**BASRAH MODERN SLAUGHTERHOUSE
BASRAH, IRAQ**

**SIGIR PA-09-189
APRIL 27, 2010**

Summary of Report: PA-09-189

Basrah Modern Slaughterhouse

Figures 2 and 3. Conceptual designs for the slaughterhouse project (Courtesy of GRS)

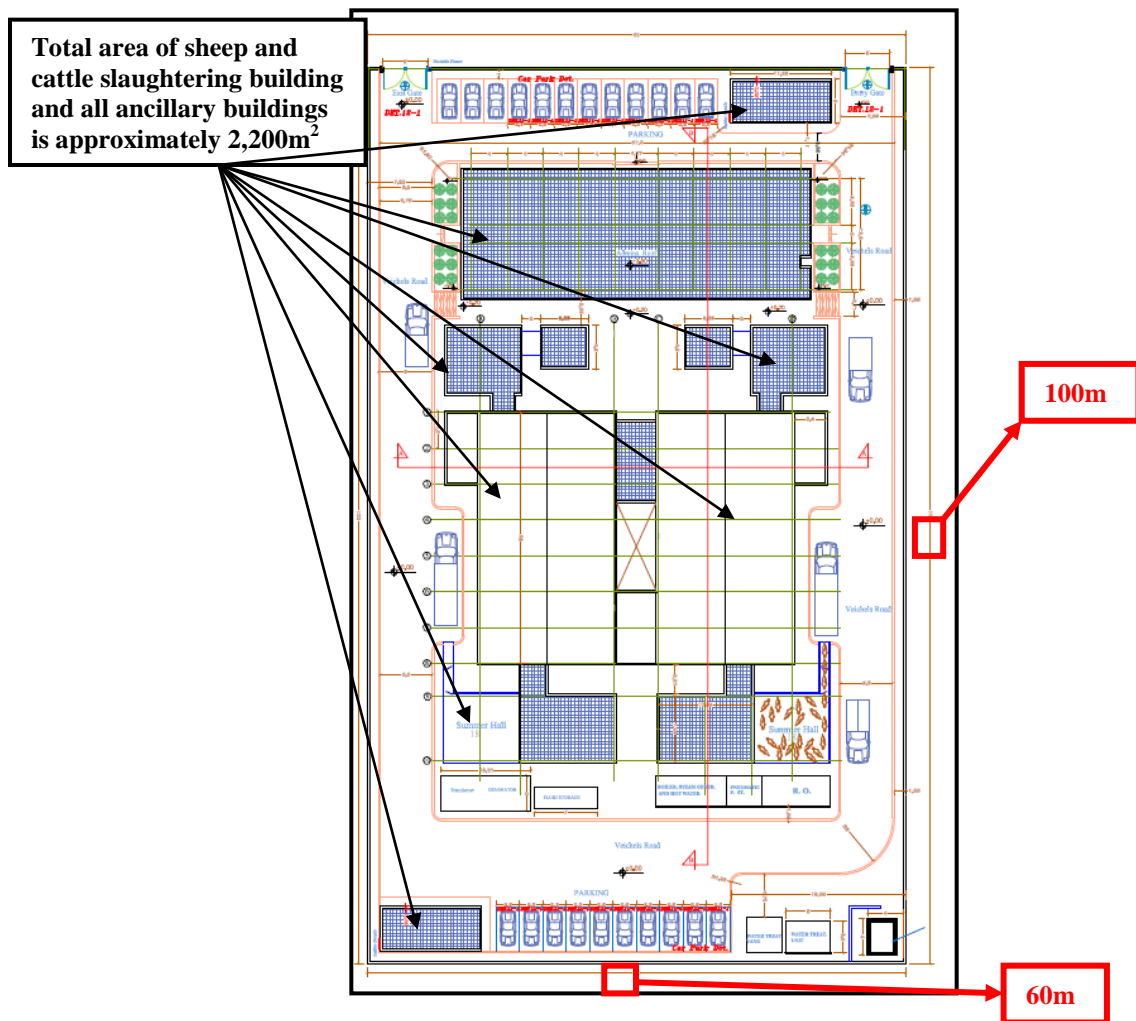
SIGIR reviewed the SOW and the GRS-provided conceptual designs. SIGIR found that the SOW lacked a process flow diagram to identify the required building sizes; while GRS provided two completely different types of slaughterhouse facilities as conceptual designs (Figures 2 and 3). One conceptual drawing indicates one slaughtering building; while the other conceptual drawing showed two slaughtering buildings. In addition, the conceptual designs left large gaps for personal interpretation.

As the designs were further disseminated through GRS, the project’s construction representative also identified two discrepancies. Specifically, “*the SOW calls for the ‘operational area’ to be twice the dimensions of the conceptual drawings. The dimensions of the conceptual drawings provide for an operational area of 1,728 sq. meters. Your [the contractor’s] design shows an operational area of 840 sq. meters. This amount is about half of the area required by the contract.*”

The resident office provided SIGIR all project documentation which contained two conceptual drawings. However, the Contracting Office at GRS headquarters maintained the official contract file and the set of drawings that were referenced in the solicitation's statement of work. The Contracting Office only issued one conceptual drawing, figure 2 on page seven of the report, with the solicitation. The Contracting Office used the conceptual drawing that illustrated one slaughterhouse building whose dimensions were 15m x 30m.

Had SIGIR used the conceptual drawing contained in the official contract and project files, figure 2 on page 7 of the report, their computations would have agreed with the contractor-submitted proposal.

The conceptual drawing to which the construction representative was referring was not the conceptual drawing on which the contractor bid. The construction representative referenced an older conceptual drawing (figure 3 on page 7 of the report), not the official drawings. The older conceptual drawing which was never included in the contract contained two slaughterhouses; each measured 14.6m x 29.6m or 432.16m². Using the older conceptual drawing and doubling the operational area, as the statement of work required, would yield an operational area of 1,728.64m² - 2 buildings x (2 x 432.16m²); the area the construction representative noted and SIGIR quoted in its report. However, the official SOW referenced a conceptual drawing with building measurements of 15 m x 30m. The contractor submitted drawings showing two similarly sized buildings which he subsequently built. Based on these facts no equitable adjustment is due for the building size.

Figure 5. Design indicating path of blood from the blood storage tanks to the “Water Treatment Unit” (Courtesy of GRS)

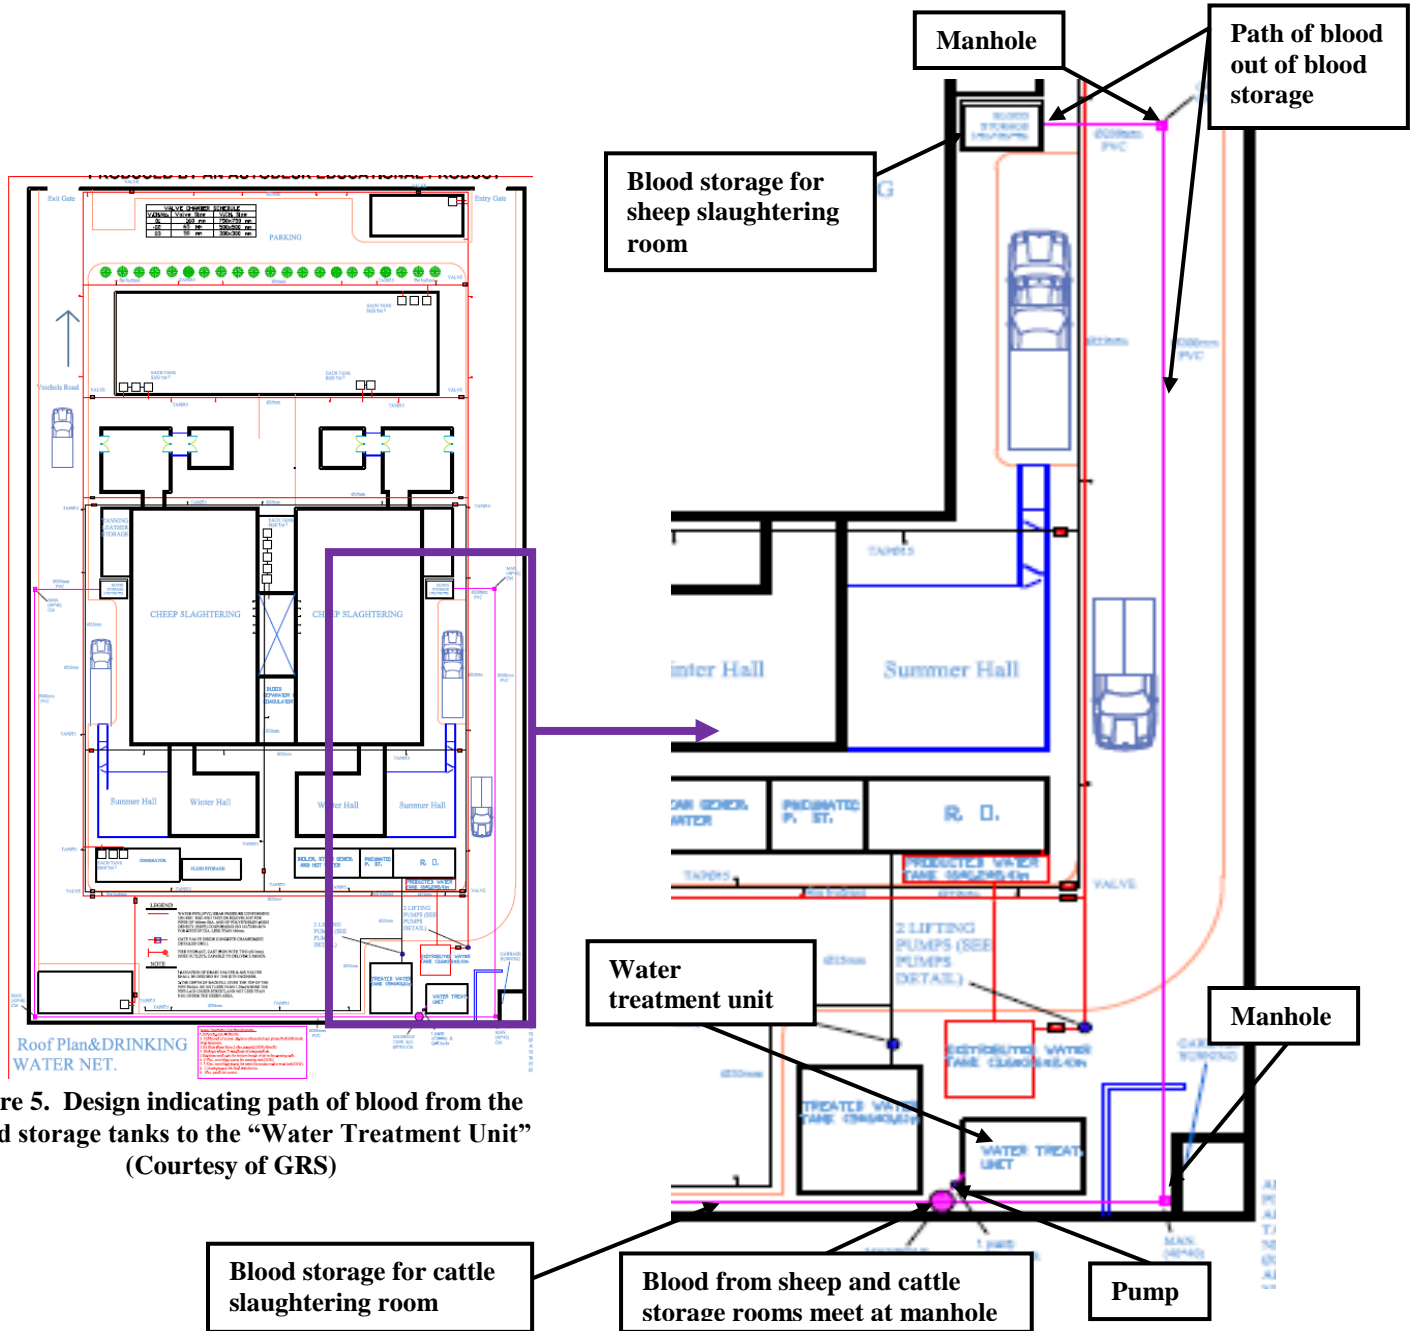
The contractor's drawing S-5 shows the blood storage tank contents conveyed via a 200 millimeter pipe to the "Water Treatment Unit." However, screening of the effluent from the storage tanks is not indicated on the plans. This will present a maintenance issue with the lines to the treatment unit if clotting of the blood is permitted in the tanks.

Figure 6. Site power distribution plan without guardhouse (Courtesy of GRS)

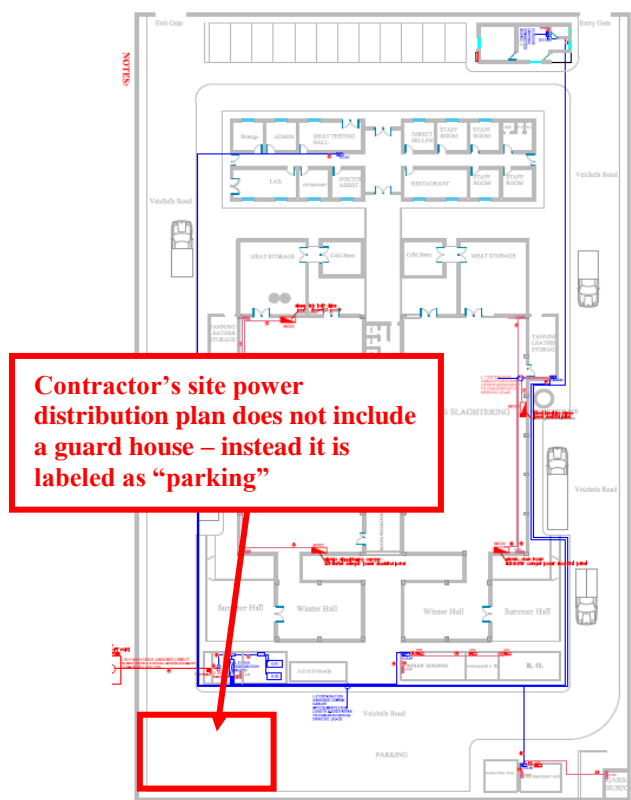
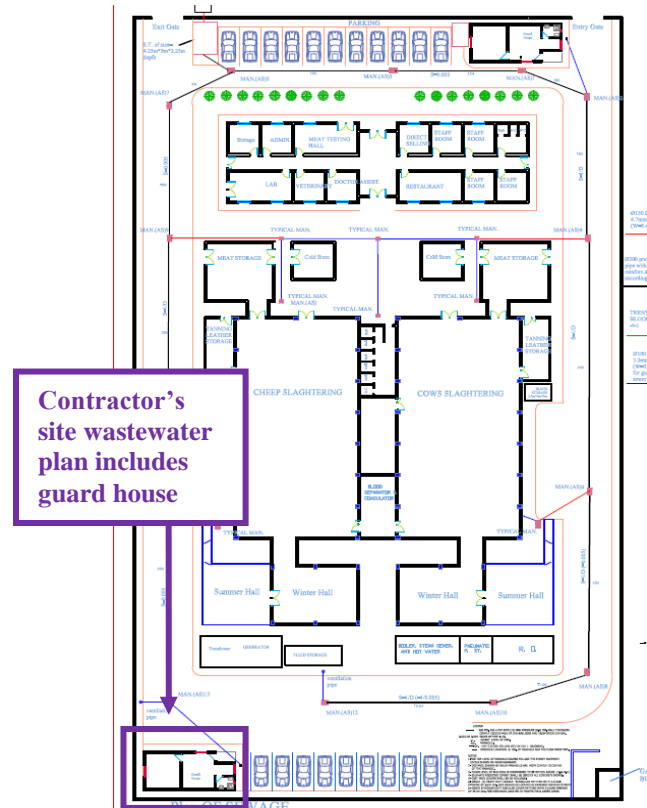
The SOW required the construction of two guardhouses with electrical fixtures and plumbing. However, on the contractor's 100% "Site Power Distribution Plan," there is only one guard house (Figure 6). The second guard house in the southeast corner is included in a majority of the contractor's other 100% drawings (Figure 7); yet for some reason the entire guardhouse is missing from the Site Power Distribution Plan. As a result of this omission, the 100% plan obviously does not illustrate the required electrical connections or fixtures to this guard house.

Figure 8. Design of perimeter fence
(Courtesy of GRS)

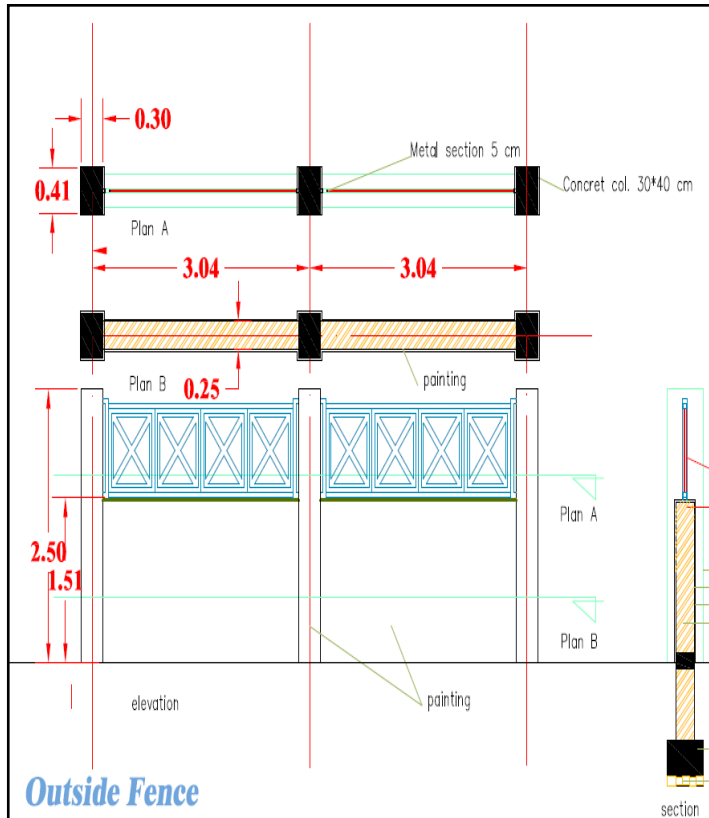
The contractor's design required the perimeter fence consist of reinforced concrete foundation, columns, and metal trusses between the columns. Concrete masonry unit panels, covered with cement mortar and stucco, were constructed between the columns to form a solid barrier (Figure 8).

At the time of the site visit, the perimeter fence was partially complete (Site Photo 3). The fence appeared to be adequately constructed, and when finished, should provide security for the slaughterhouse operators and equipment, as well as, from stray dogs and rodents attracted by the slaughterhouse.

**Figure 9. Contractor's detail for placement of lintels for doors and windows
(Courtesy of GRS)**

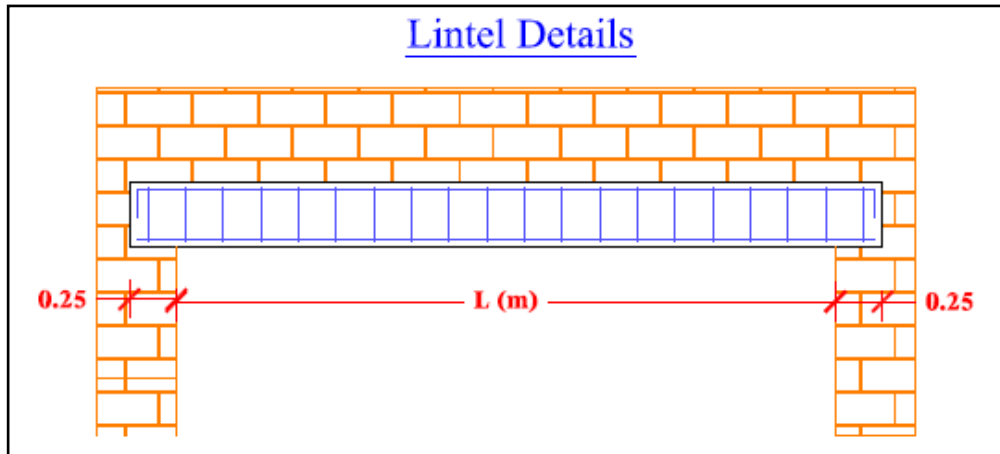
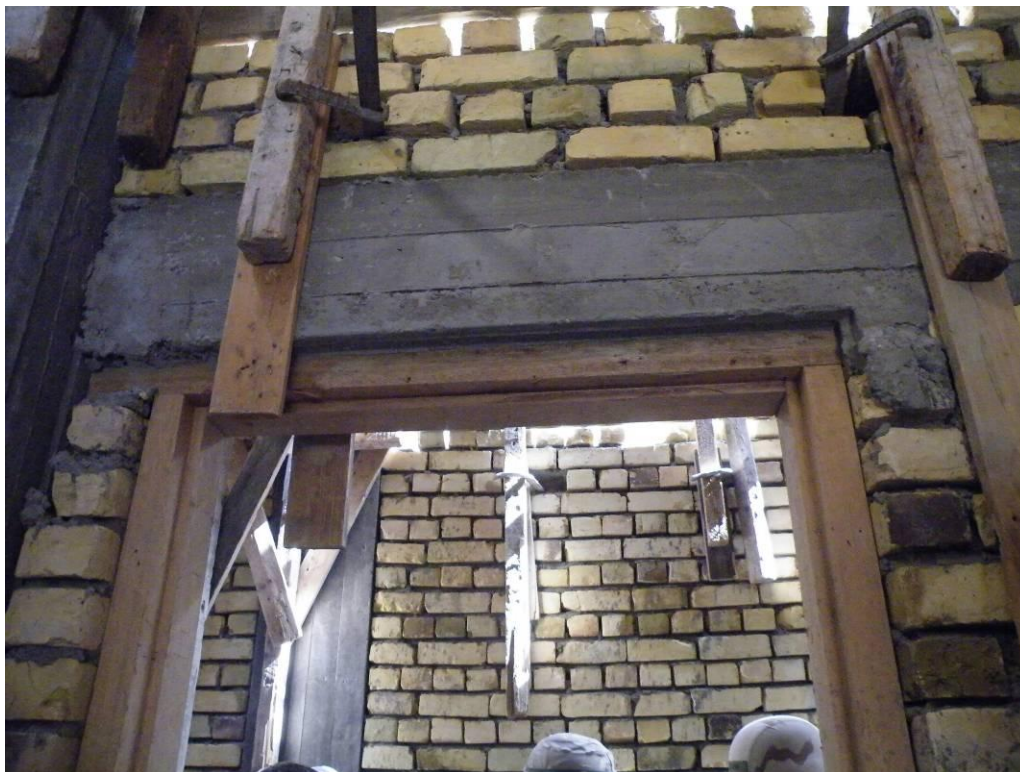
SIGIR identified potential issues with the contractor's placement of lintels and tie beams¹¹. The contractor's structural drawing S1 required lintels for all doors or windows to have at least 25 centimeters (cm) of bearing on the brick masonry supports (Figure 9). During the site visit, SIGIR identified several locations where lintels for door openings were not placed according to the contractor's structural drawings (Site Photo 4).

SIGIR's concern is that these lintels do not offer sufficient support and may result in failure of the brick masonry supports. SIGIR brought this issue to the attention of GRS. After reviewing the issue, GRS responded:

The lintel detail shown on sheet S1 is a generic detail. Where the door or window fell close to the frame of the building and the required length of brick could not be obtained, one end of the lintel was doweled into the column for vertical support only. All free ends of lintels have more than the required 25cm. A detail of the individual lintel placements shall be provided.

SIGIR believes that dowels, if properly utilized¹³, would provide the necessary support for lintels with less than 25cm of brick length. Since GRS is certifying that the contractor appropriately used dowels, then this issue has been adequately addressed.

**Site Photo 5. Strip footers tied together at the base
(Courtesy of GRS)**

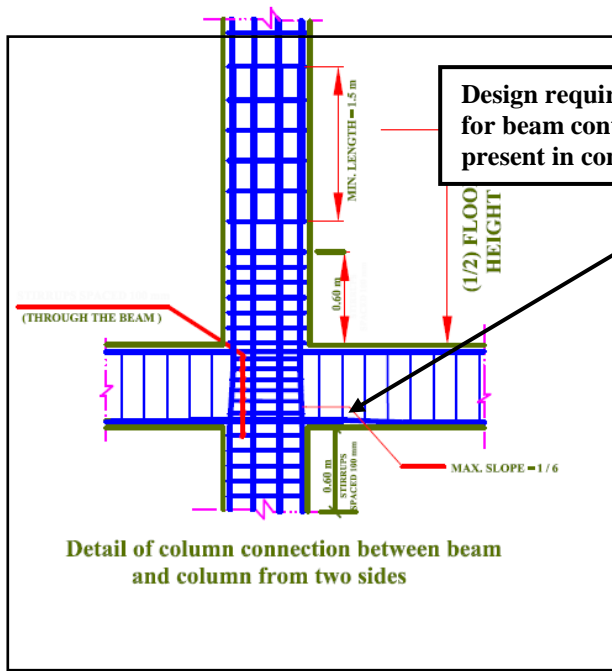
Due to the poor soil conditions at the project site, the contractor's design drawing S3 indicates that the slaughterhouse buildings will be primarily constructed on large strip footings along column rows A, B, C, and D with smaller spread footings for the miscellaneous project components. In addition to the strip footings, tie beams are proposed between each column in rows B and C to connect the two slaughterhouse buildings. These beams are detailed on the contractor's drawing S7 with information on their elevation, dimensions, and placement of reinforcement.

S3 is a general detail section. These are not specific to one structure and are really a carryover from the 35% design. The original intent was to use independent spread footers which would require the tie beams as shown in the detail on sheet s-3. However since the soil properties were low, strip footers were used in lieu of independent spread footers. The strip footers can be seen on sheet S-6 through S-9 (footers 1-6). The strip footers are already tied together at the base and do not need additional tie beams as shown on sheet S-3 [Site Photo 5]. This detail shall be removed from the drawings in the as built drawings. The pictures below shows the base of the columns tied together with strip footers as designed.
